# Access Compliance Report

## Public Rights-of-Way

### (Curb Ramps)

Intersection ID: 11894	Main Street: N_BREVARD_ST	Cross Street: E_12TH_ST	Location: N
ADA ID: BB4043242B8D	Ramp Type: Perp	Initial Pass/Fail: Fail	Overall Compliance: No
Severity Score: 12.5			
Codes/Mitigation Info/Possible Solution		Field Measurements/Component Compliance

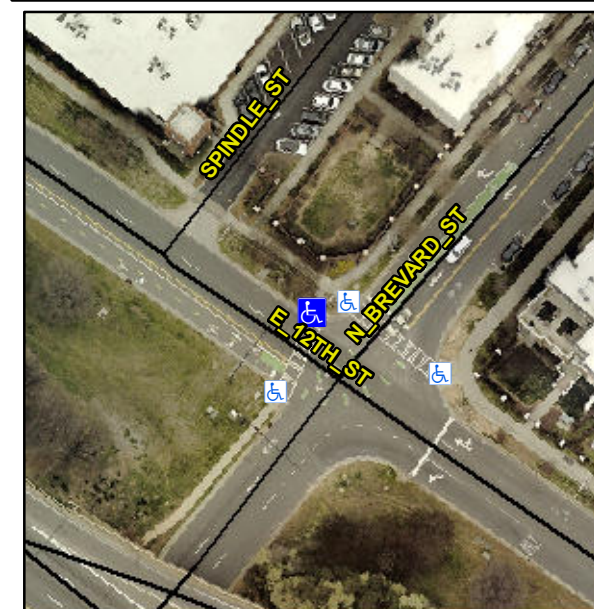
**Not Found, R304.2.2**

Compliance	Description	Data	Compliance	Description	Data
N/A	Ramp Length (in)	74.0	No	Ramp Slope (%)	8.7
Yes	Ramp Width (in)	48.0	Yes	Ramp XSlope (%)	0.3
N/A	Flare Type LT	N/A	N/A	Flare Type RT	N/A
N/A	Flare Slope LT (%)	N/A	N/A	Flare Slope RT (%)	N/A
N/A	Flare Traversable LT?	N/A	N/A	Flare Traversable RT?	N/A
N/A	Landing Length (in)	N/A	N/A	DWS Provided?	N/A
N/A	Landing Width (in)	N/A	N/A	DWS Contrast?	N/A
N/A	Landing Slope (%)	N/A	N/A	DWS Length (in)	N/A
N/A	Landing X Slope (%)	N/A	N/A	DWS Full Width?	N/A
N/A	Landing Curb? (Y/N)	N/A	N/A	DWS Offset (in)	N/A
N/A	Shared Landing?	N/A			
N/A	Gutter Ponding?	Yes	N/A	Gutter Slope (%)	N/A
N/A	Gutter Lip Ht (in)	N/A	N/A	Gutter X Slope (%)	N/A
N/A	Painted X Walk1?	Yes	N/A	Painted X Walk2?	N/A
	X Walk 1 Direction	To SW		X Walk 2 Direction	N/A
N/A	X Walk 1 Width (in)	87.0	N/A	X Walk 2 Width (in)	N/A
	X Walk 1 Slope (%)	3.5		X Walk 2 Slope (%)	N/A
	X Walk 1 X Slope (%)	0.6		X Walk 2 X Slope (%)	N/A

**Remove & Replace Entire Ramp.**
